REFERENCE	BT_2010_FR20_18
DATE	6 th August 2010
SUBJECT	Roll hoop fitting enforcement
PART	Roll hoop /tub

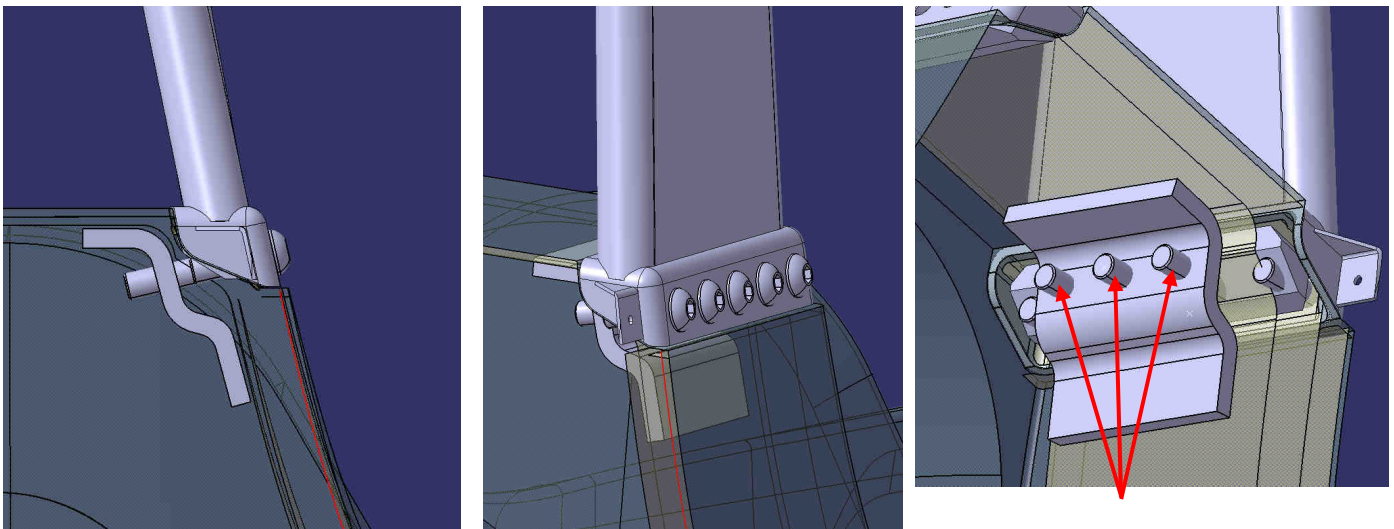
Both the tub and the roll hoop already exceed the objectives but the bonding between those two elements can still be improved. To reinforce the fitting of the roll hoop, an update must be conducted by a Caparo technician at your premise before your next race.

The modification consists in replacing the 10 fitting screws by specific screws with a bigger diameter and adding stiffening plate from the inside.

M8 Knuts must be tightened here on both sides (Torque = 23 N)

This update will appreciably increase the resistance of the roll hoop, for instance moving from 65 kN to 101 kN against y axis.
